<b>Subject:</b> REAR MUDGUARD IS WARPED CAUSING POOR APPEARANCE/NOISE	<b>Bulletin No:</b> 09-028/15
	<b>Last Issued:</b> 07/24/2015

2014-16 Mazda3 (Mexico built) vehicles with VINs starting with 3MZ

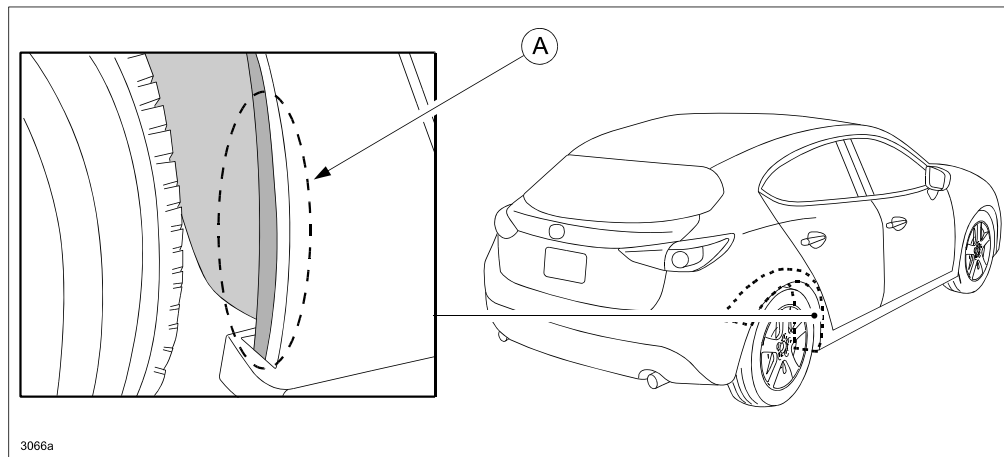
Some vehicles may exhibit a warped rear mudguard with the surface edge (A) visible from outside the vehicle, causing a poor appearance. In the worst case, it could touch the tire and cause a rubbing noise. The deformation is due to product variation.

1. Verify customer concern.
2. Replace mud guards (both sides) with ones used for Japan production Mazda3 (JM1) according to the instructions on MS3 online or the Workshop Manual (section 09-16 MUDGUARD REMOVAL/INSTALLATION).
3. Verify repair.

Part Number	Description	Qty.
B45A-56-1H1	Guard (R), mud-rear	1
B45A-56-1J1	Guard (L), mud-rear	1
